Service Bulletin

PRELIMINARY INFORMATION

Subject: Malfunction Indicator Lamp (MIL) Light On, Reduced Power Mode, DTC Set, Poor Performance/Shifts

Models: 2013-2017 Chevrolet Equinox
2013-2017 GMC Terrain
Equipped with 3.6L Engine (RPO LFX)

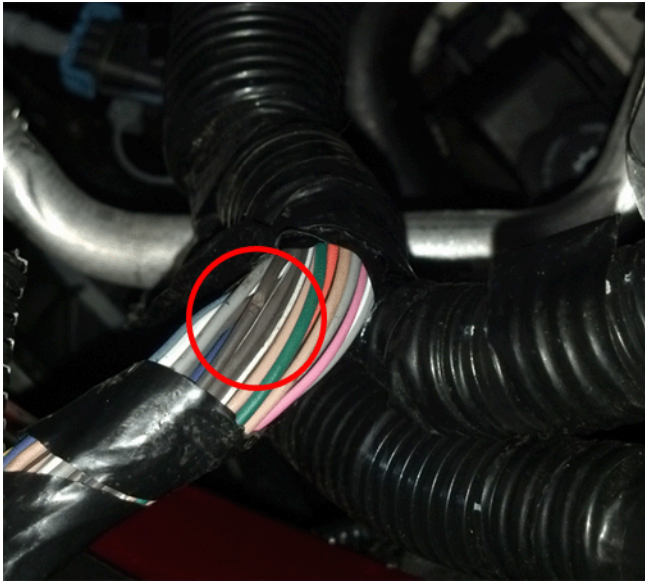
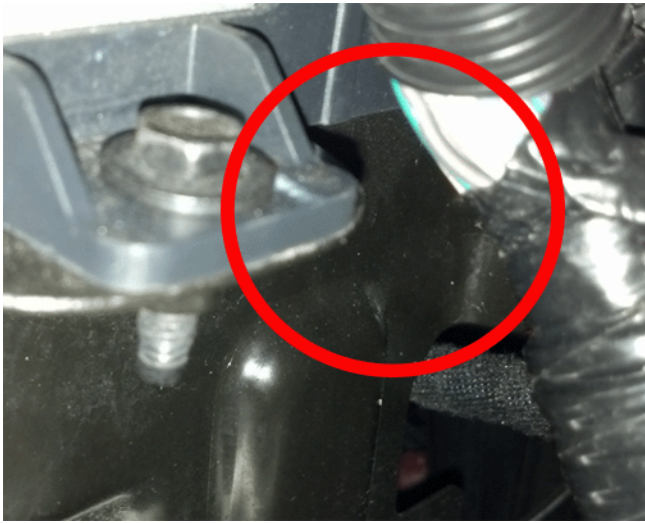
This condition may be caused by the ECM wiring harness rubbing on the ECM bracket. The harness may have chafing or damage to the wires. Contact with the edge of the bracket may result in a rub-through of the wires within that harness.

Technicians should inspect the ECM harness (off of Engine Control Module X1 connector) for any damaged wires at the location shown below and repair any damaged wires found. Refer to Wiring Repairs in SI. After the repair is completed, wrap Woven Polyester Electrical Tape (PET) (preferred) or equivalent anti-abrasion tape around the wires on the harness.

If no damage is found, wrap Woven Polyester Electrical Tape (PET) (preferred) or equivalent anti-abrasion tape around the wires on the harness.
